## 2. SITE CHARACTERISTICS

In Section 2.1.1.1 of the site safety analysis report (SSAR) for the Grand Gulf Nuclear Station (GGNS) early site permit (ESP) site, the applicant presented information concerning site location and site area that could affect the design of structures, systems, and components (SSCs) important to the safety of a nuclear power plant(s) falling within the applicant's plant parameter envelope (PPE) that might be constructed on the proposed ESP site.

Figure 2.4-1 SSAR Figure 2.1-1 showing location and extent of PPBA

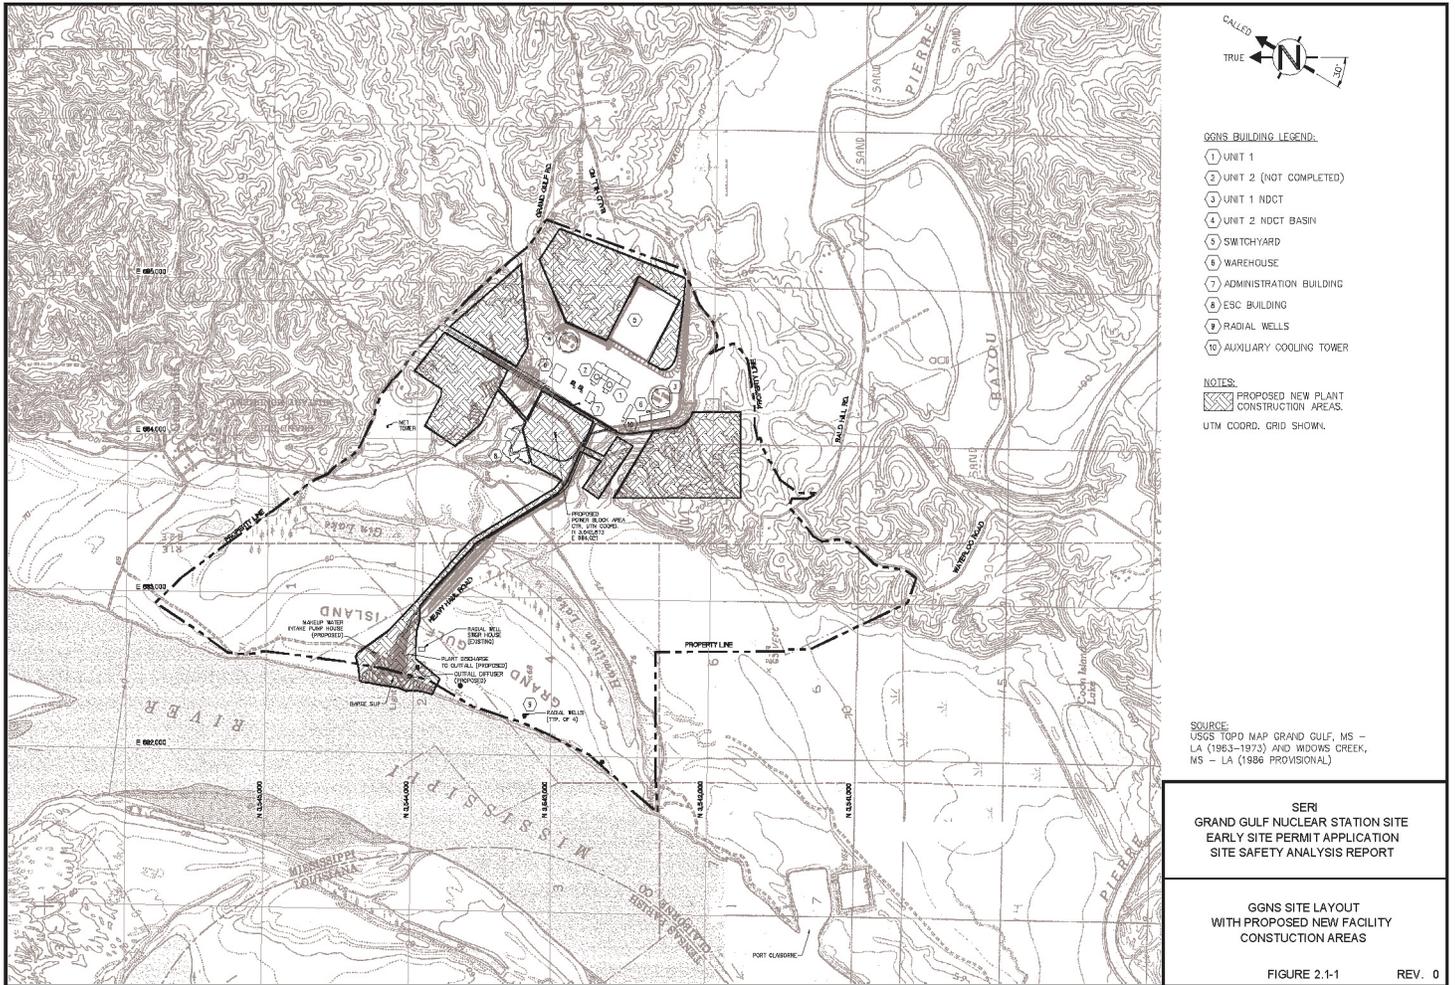
In RAI 2.4.1-1, the NRC staff asked SERI to provide survey coordinates, including elevations, for the bounding areas of all ESP facility safety-related structures. The staff also requested that the applicant provide the coordinates of existing aquifers in the bounding areas, particularly perched aquifers. In response to RAI 2.4.1-1, the applicant stated that the UTM grid coordinates for the center of the location of the powerblock area for a new nuclear unit are approximately N3,542,873 meters and E684,021 meters in UTM Zone 15. These UTM coordinates correspond approximately to 32E N latitude and 91E3' W longitude. SERI also stated that all safety-related structures will be contained within the proposed powerblock area (PPBA) indicated on SSAR Figure 2.1-1, included below as Figure 2.4-1.

In RAI 2.4.1-1, the staff asked SERI to provide survey coordinates, including elevations, for the bounding areas of all ESP safety-related structures. The staff also requested that the applicant provide the coordinates of existing aquifers in the bounding areas, particularly perched aquifers. In response to RAI 2.4.1-1, the applicant stated that the UTM grid coordinates for the center of the location of the powerblock area for a new facility are approximately N3,542,873 meters and E684,021 meters in UTM Zone 15. According to the applicant, these UTM coordinates correspond to approximately 32E N latitude and 91E3' W longitude. SERI also stated that all safety-related structures will be contained within the PPBA indicated on SSAR Figure 2.1-1.

**Figure 2.4-5 Grand Gulf ESP site vicinity map**

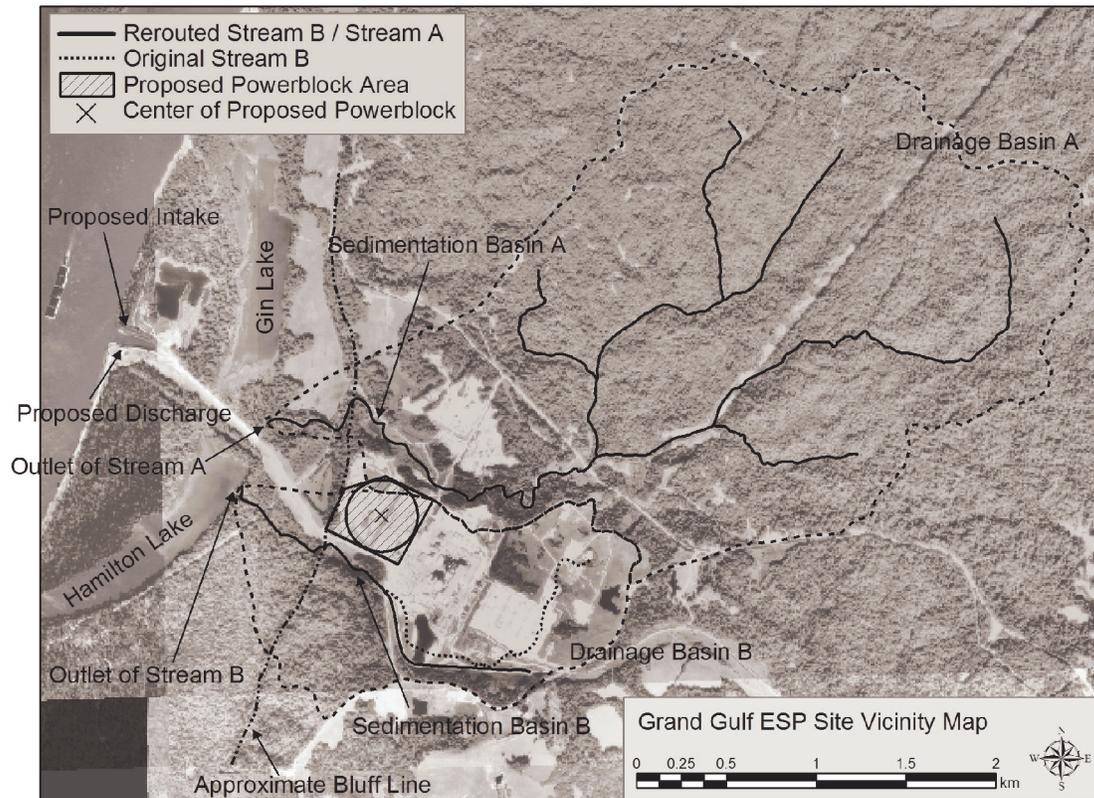
The staff's review of SSAR Figures 2.1-1 and 2.1-2 revealed that, although the coordinates inscribed on these figures for the center of the proposed powerblock are the same as those mentioned in applicant's response to RAI 2.4.1-1, the coordinates do not agree accurately with the position of the center of the proposed powerblock as drawn on these figures. The staff independently created a map to more accurately locate the center of the proposed powerblock. Figure 2.4-5 shows this map.

The map shown in Figure 2.4-5 uses the UTM Zone 15N North American Datum (NAD) 1983 geographic projection. As shown on SSAR Figures 2.1-1 and 2.1-2, the applicant's PPBA is located north of the heavy haul road, east of the bluffs, and southeast of the ESC building. The staff created the polygon labeled "Proposed Powerblock Area" on Figure 2.4-5 closely following the location of applicant's PPBA shown on SSAR Figures 2.1-1 and 2.1-2. The staff overlaid the largest circle that could fit inside the PPBA as shown in Figure 2.4-5. The staff assumed that the center of this circle represents the location of the center of the proposed powerblock. The UTM coordinates determined by the staff for the center of the proposed powerblock are N3,543,266.06 meters and E684,017.28 meters, with reference to the UTM Zone 15N NAD 1983 geographic projection.

The staff also overlaid the applicant-stated coordinates of the center of the proposed powerblock on the map and found that these coordinates place the proposed powerblock approximately 302 feet southwest of the staff-estimated coordinates mentioned above and closer to Stream B. Because of this discrepancy between the coordinates provided by the applicant and the plotted location of the powerblock on Figures 2.1-1 and 2.1-2, the staff cannot determine the actual location of the powerblock on the ESP site. Therefore, the staff required additional information on the true coordinates of the center of the powerblock. This was

Open Item 2.4-1. The staff intended to specify the coordinates of the center of the proposed powerblock as a permit condition subsequent to the satisfactory resolution of Open Item 2.4-1.

In response to Open Item 2.4-1 (Response to Request for Additional Information to Resolve the Grand Gulf Early Site Permit draft Safety Evaluation Report Open Items, System Energy Resources, Inc., June 21, 2005), the applicant stated that the UTM coordinates indicated in the SSAR, ER, and Environmental Policy Institute documents were inaccurate because of an error in a spreadsheet which was used to calculate UTM coordinates corresponding to Mississippi West grid coordinates. The applicant converted the coordinates of the center of the ESP powerblock, N550,099 feet and E277,346 feet in the Mississippi West grid coordinate system, to N3,543,261 meters and E684,018 meters in the UTM Zone 18 NAD 83 projection system using USACE software Corpscon Version 6.0. The applicant revised Figures 2.1-1, 2.1-2, 2.2-4, 2.4-1, 2.4-10, and 2.4-33 of the SSAR. The applicant also revised SSAR Sections 1.2, 2.1.1.1, and 2.4.1.1; Part 1, "Administrative Information," in Section 1.1; Part 4, "Emergency Planning Information," and Figures 2-1 and 2-3; and Section 2.1.1, ER Figures 2.1-1, 2.2-1, 2.3-1, 2.3-7, 2.3-12, and 2.3-20; and ER Sections 1.1, 2.1, 2.3, and 4.5.1 to include corrected UTM coordinates.

**Figure 2.4-8 Simplified cross-section of the Mississippi River near the ESP site (not drawn to scale)**

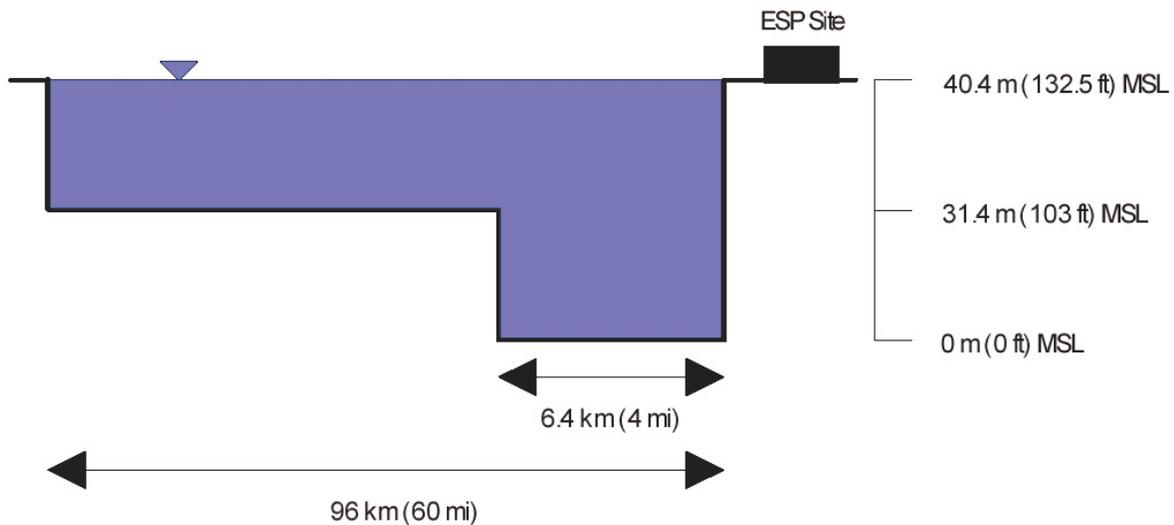
The staff carried out a simplified bracketing estimation of the discharge needed to raise the water surface elevation near the GGNS site above the existing GGNS Unit 1 plant grade of 132.5 feet above MSL. The staff assumed a simplified cross-section for the Mississippi River near the GGNS site, as shown in Figure 2.4-8. The staff conservatively assumed that the width of the floodplain is 60 miles, even at a water surface elevation of 132.5 feet above MSL. The cross-sectional area of discharge is estimated as 11.5 million square feet (ft<sup>2</sup>). The wetted perimeter was estimated as 317,065 feet.

Based on a staff-assumed Manning's roughness coefficient of 0.025 for natural channels and a bed slope of 0.2 feet per mile (ft/mi), the staff estimated the discharge in the Mississippi River corresponding to a water surface elevation of 132.5 feet above MSL as 46.3 million cfs. This estimate is more than four times larger than the discharge capacity of the river at a water surface elevation of 103 feet above MSL, and about seven times larger than the applicant-estimated PMF. Therefore, the staff concluded that the ESP site is safe from flooding caused by a seismically induced dam failure upstream of the GGNS site.

**Figure 2.4-10 Minimum daily average streamflow in the USGS record for all water years 1932–1998 at Vicksburg, Mississippi. Red circles with years show six lowest historical values.**

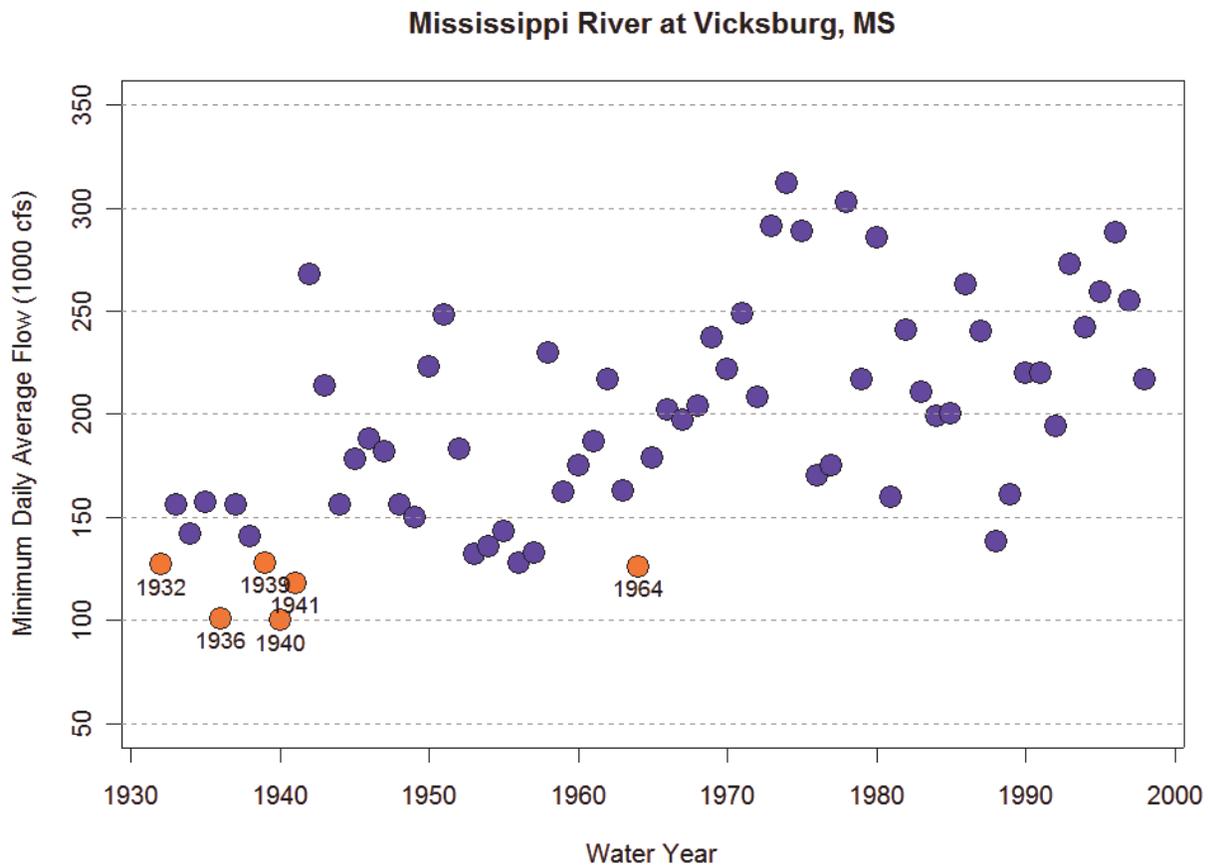
Using the USGS "National Water Information System," the staff reviewed low-water conditions based on daily streamflow records at the Vicksburg Gauging Station. Figure 2.4-10 shows the minimum daily streamflow observed at Vicksburg, Mississippi, during water years 1932–1998 as 100,000 cfs on November 1, 1939. Apparently, the applicant mistyped the date for this same streamflow as November 1, 1940, in the ESP application. According to the USACE report, "Stages and Discharges of the Mississippi River and Tributaries in the Vicksburg District, Annual Report of the District Engineers," issued 1990, a streamflow of 93,800 cfs was observed on August 31, 1936.

In ER Figure 5.3-2, SERI indicated that the ESP intake screens are expected to be located at an elevation of 23.5 feet above MSL, which is 4.9 feet below the staff-estimated minimum water surface elevation near the GGNS site and 14 feet below the USACE low-water reference plane.
